PLEASANT PRAIRIE PLAN COMMISSION MEETING VILLAGE HALL AUDITORIUM 9915 39th AVENUE PLEASANT PRAIRIE, WISCONSIN 6:00 P.M. FEBRUARY 11, 2013

Posted:_____ yr2012 dnr conservcnay purchased lots.doc B. Consider the request of Paul Schmitter, agent for CenterPoint WisPark Land Co., LLC owners of the property generally located south of 107th Street, north of 109th Street between 80th and 88th Avenues in LakeView Corporate Park for approval of **Site and Operational Plans** for the construction of a 471,403 square foot industrial building for TaChen International Inc., a stainless steel distributor.

<u>Recommendation</u>: Village staff recommends that the Plan Commission approve the **Site and Operational Plans** for the proposed 471,403 square foot industrial building to be occupied by TaChen International Inc. subject to the comments and conditions of the Village Staff Report of February 11, 2013.

93-4-123-191- 125 Rezone from R-5 and C-1 to C-3

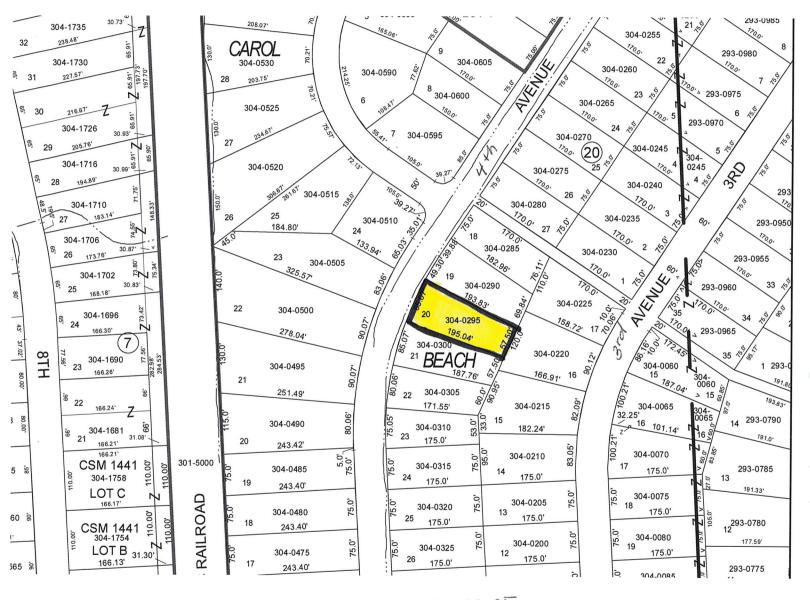
Properties that have been acquired in the public's interest in 2012 were evaluated and are proposed to be rezoned into an appropriate zoning classification pursuant to The Plan. The following zoning map amendments area proposed.
